ROADWAY PLANS

JUDGE ORR ROAD RV PARK AND STORAGE

EL PASO COUNTY, COLORADO

**RANGE FLOWER WAY
 ROADWAY PLAN (PRIVATE)**
 URBAN NON-RESIDENTIAL COLLECTOR
 SCALE = 1" = 60'

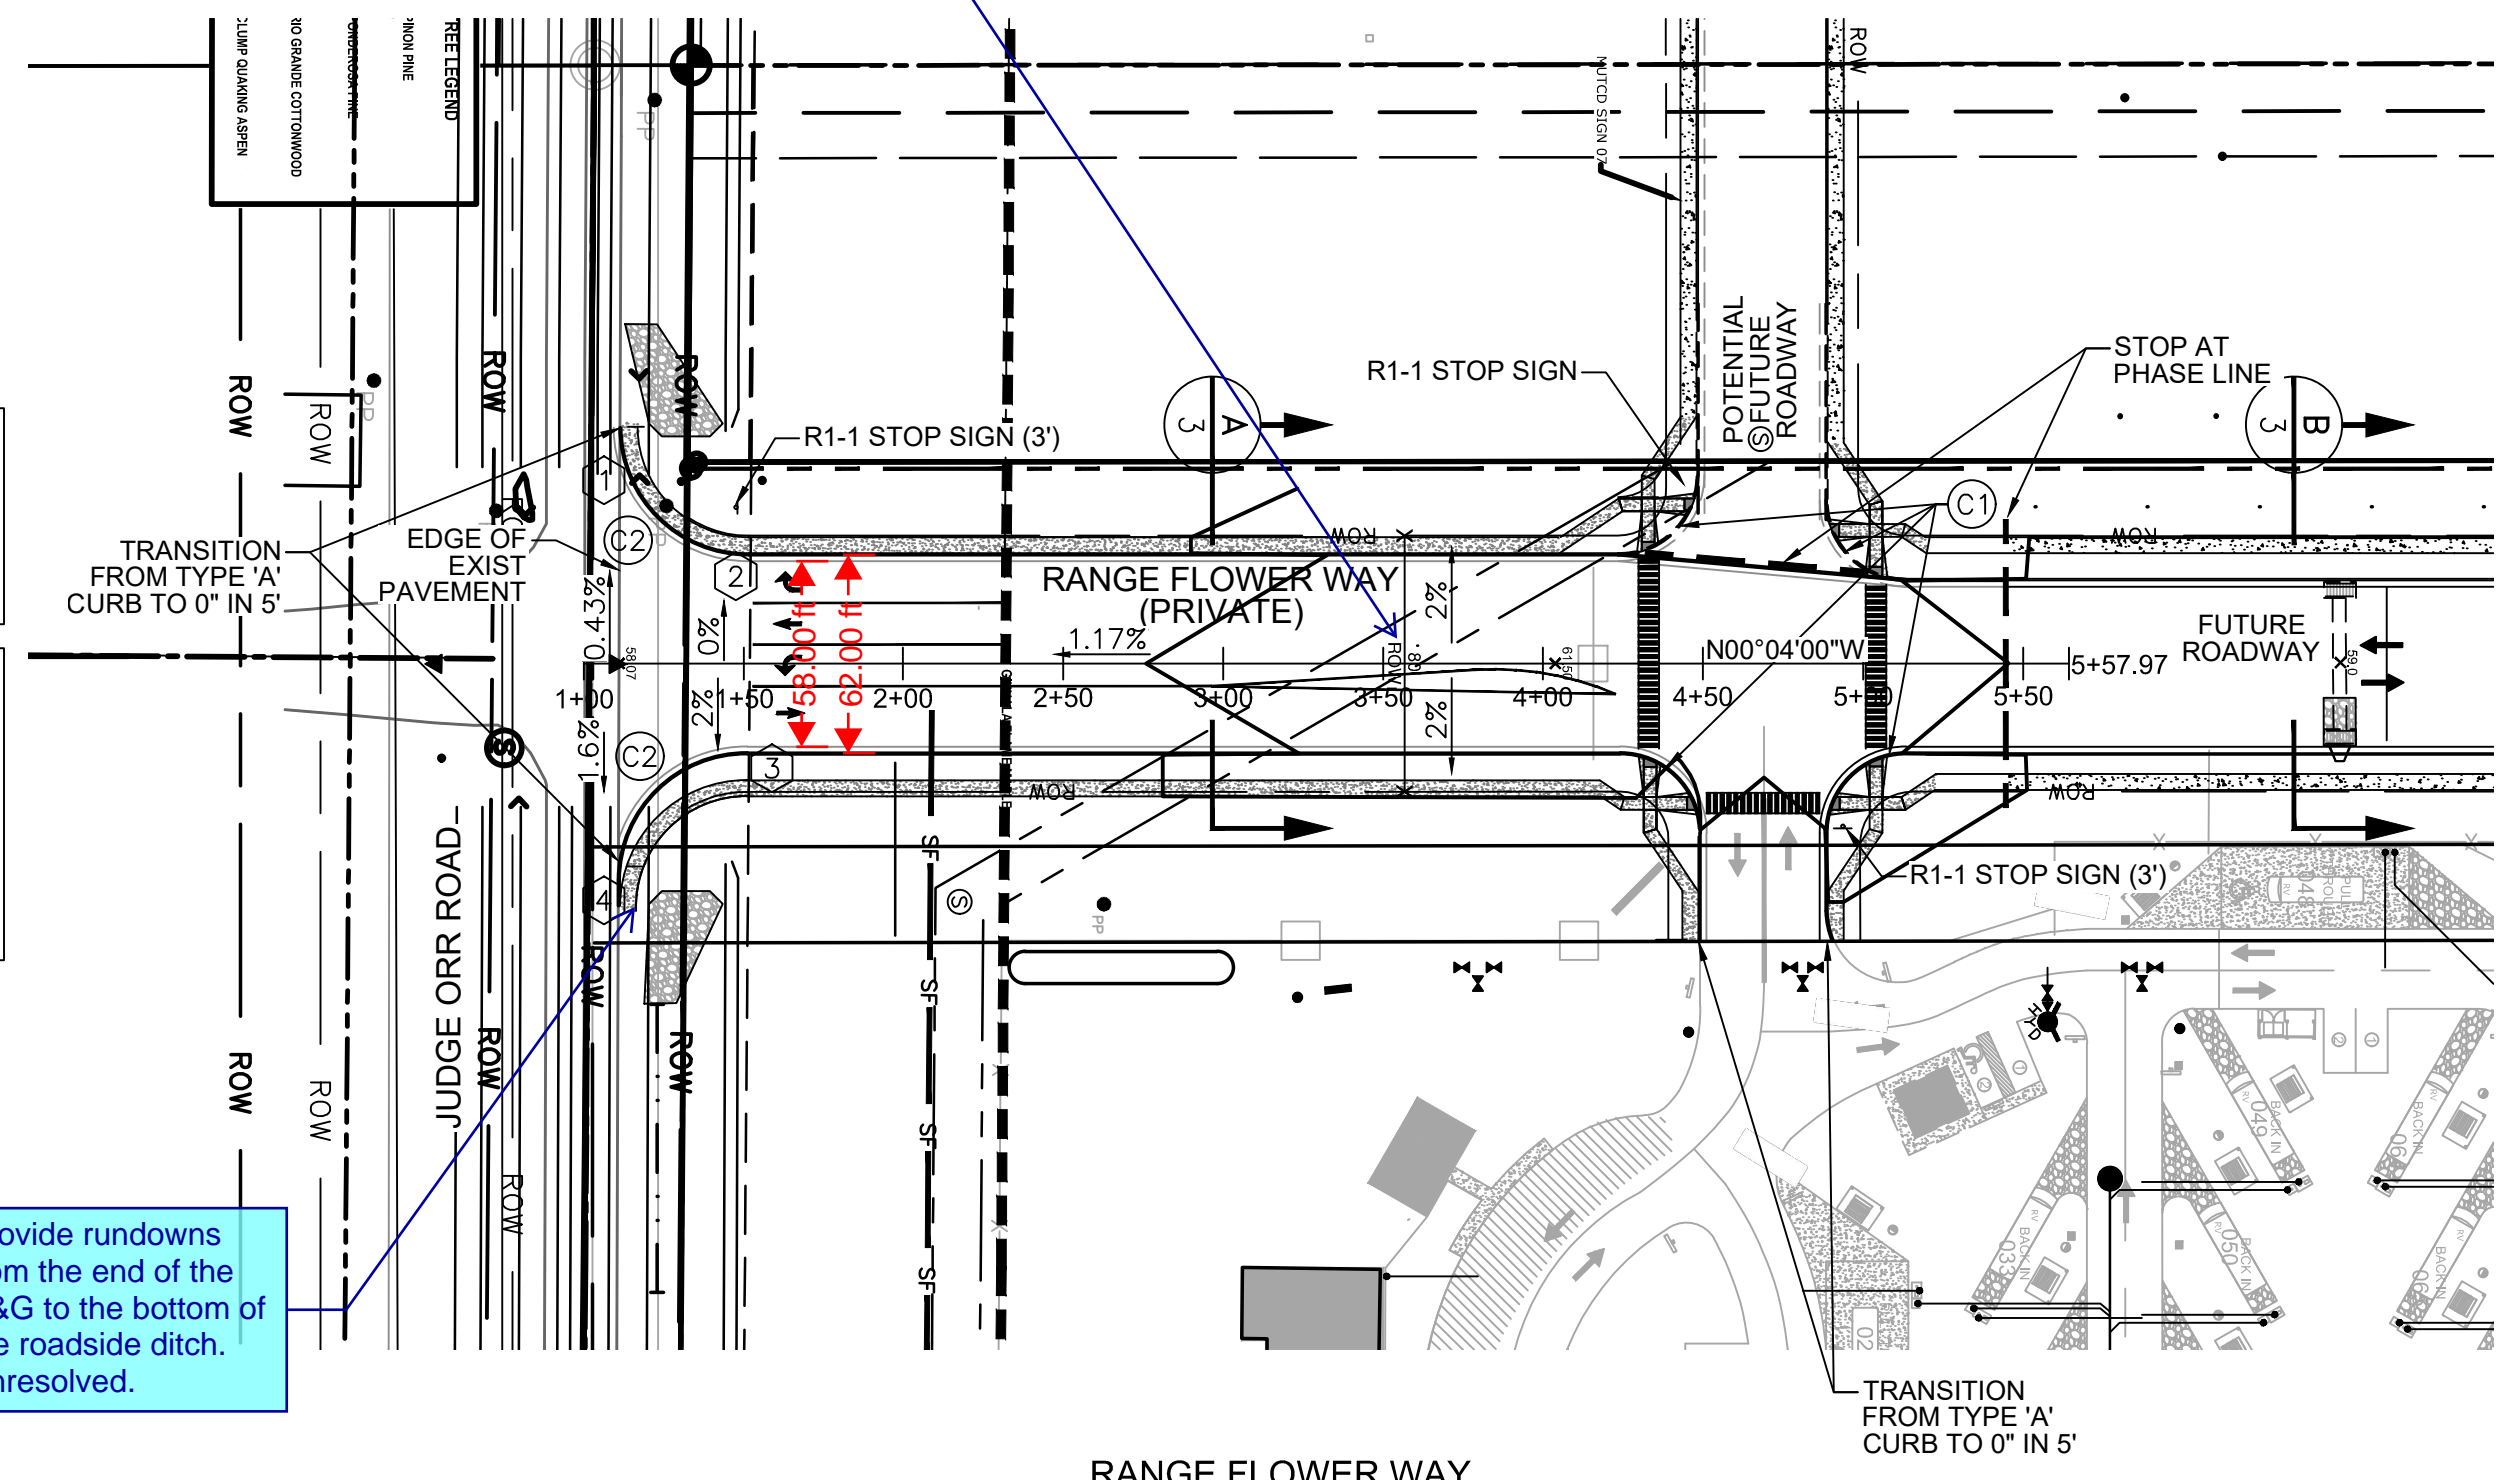
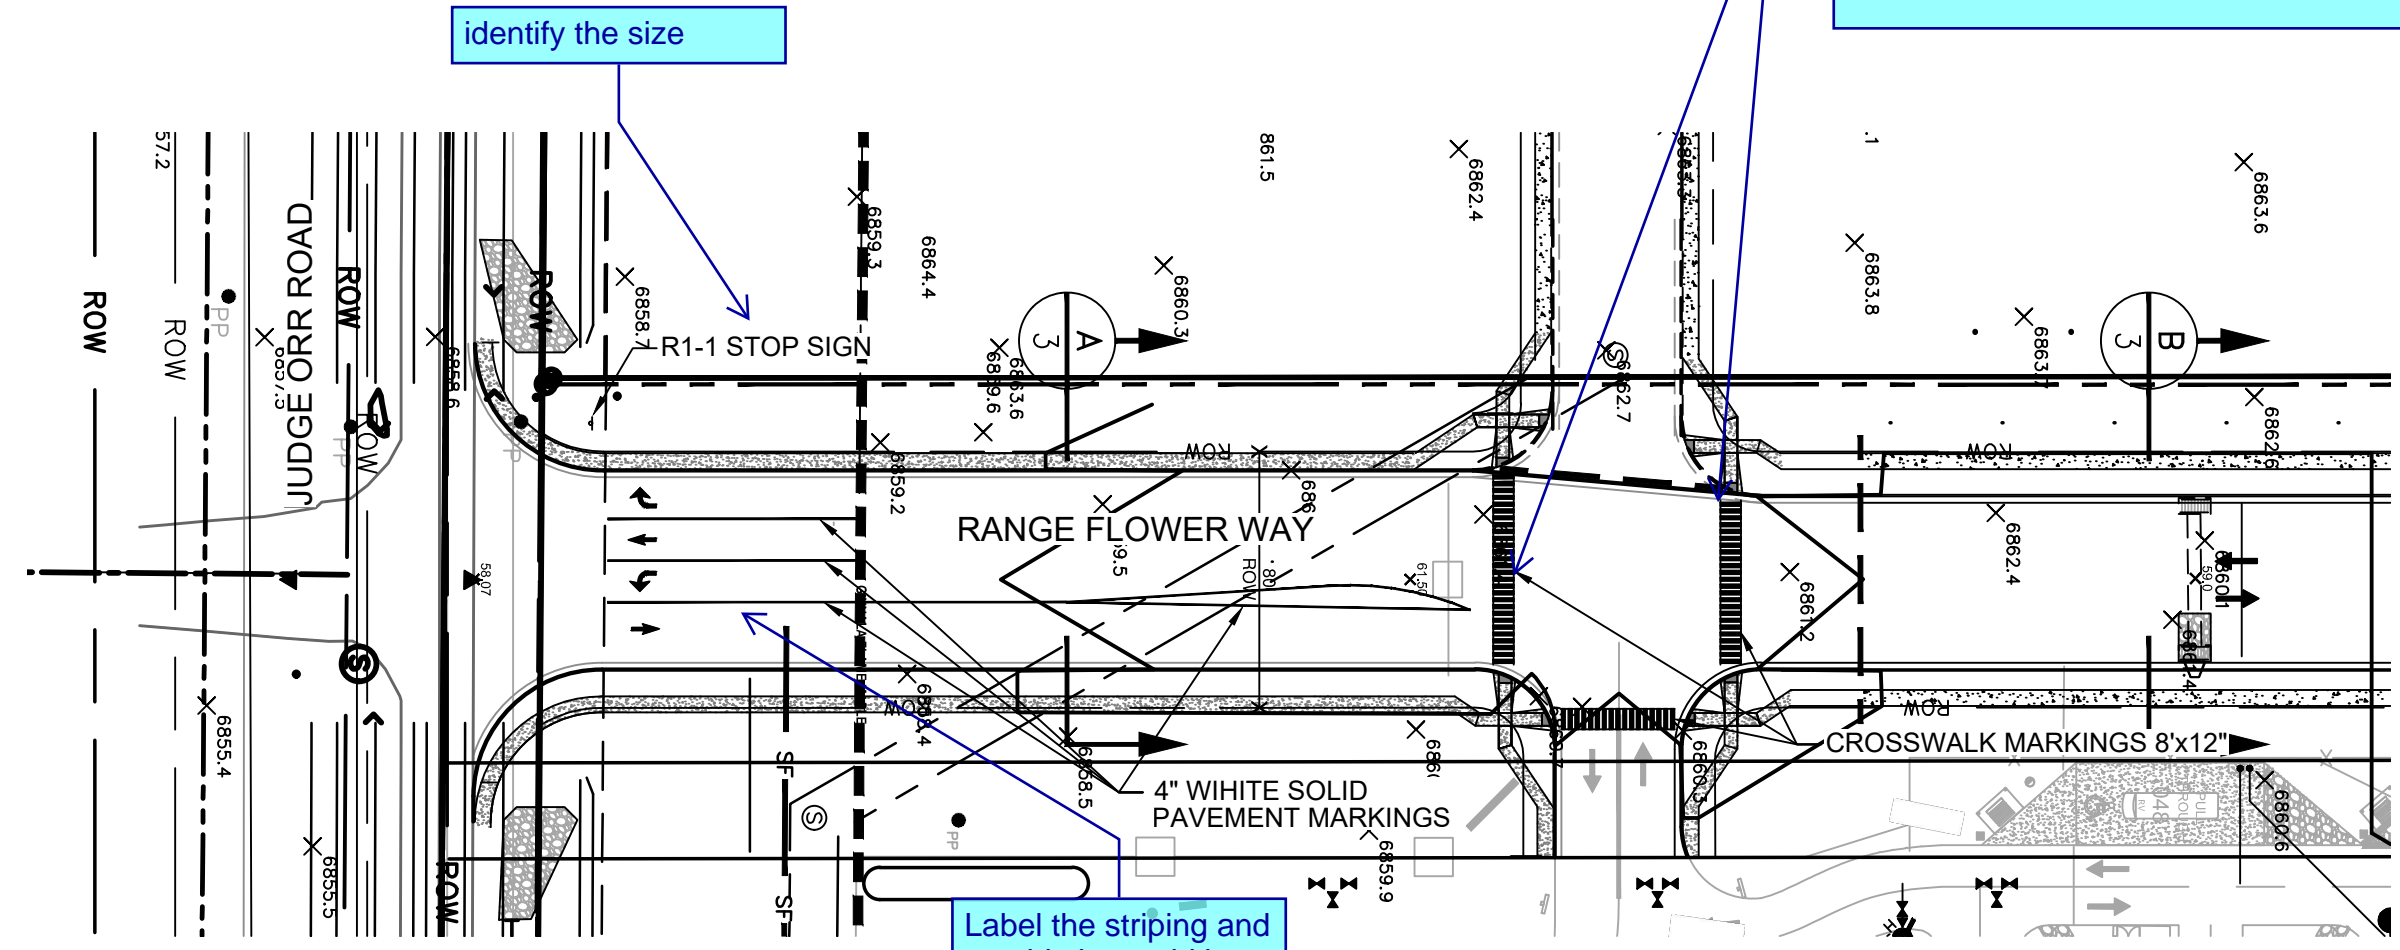
ROW should be labeled as "future public ROW". Add a note that the ROW is conceptual only and will be finalized in the subdivision stage. As you layout the anticipated ROW that the applicant plans to dedicate in the future consider the criteria which requires 14' of clear zone for Urban Non-Residential.
 Unresolved.

Remove all crosswalks since the plan at this time is to construct a continuous curb on the west side since access from the west is to be determined. The PUD development to the west will be tasked with upgrading the intersection once finalized.

Provide rundowns from the end of the C&G to the bottom of the roadside ditch.
 Unresolved.

ROW should be labeled as "future public ROW". Add a note that the ROW is conceptual only and will be finalized in the subdivision stage. As you layout the anticipated ROW that the applicant plans to dedicate in the future consider the criteria which requires 14' of clear zone for Urban Non-Residential.

Unresolved.

Provide rundowns from the end of the C&G to the bottom of the roadside ditch.
 Unresolved.

Remove all crosswalks since the plan at this time is to construct a continuous curb on the west side since access from the west is to be determined. The PUD development to the west will be tasked with upgrading the intersection once finalized.

Label the striping and provide lane widths and lengths of striping: FLOWER WAY STRIPING PLAN
 UNRESOLVED.
 SCALE = 1" = 60'

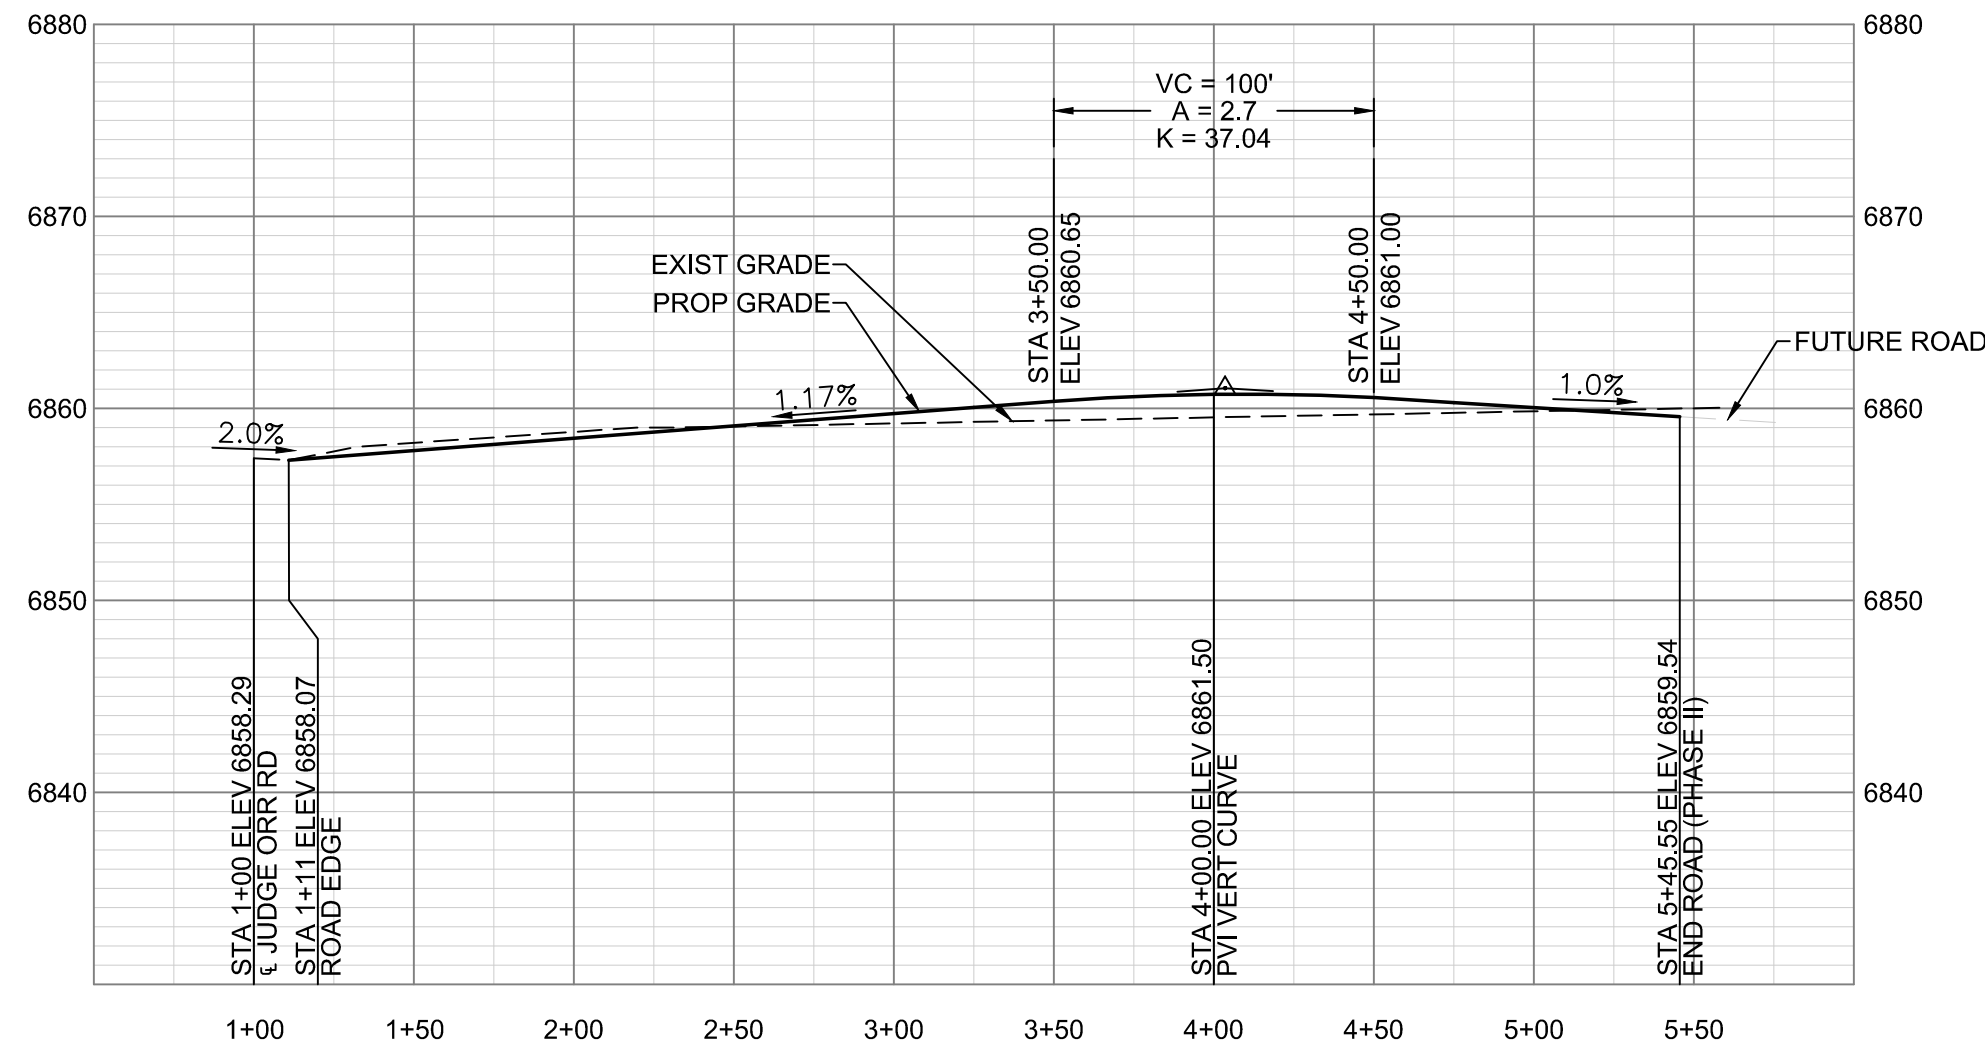
Label the striping and provide lane widths and lengths of striping.

Unresolved.
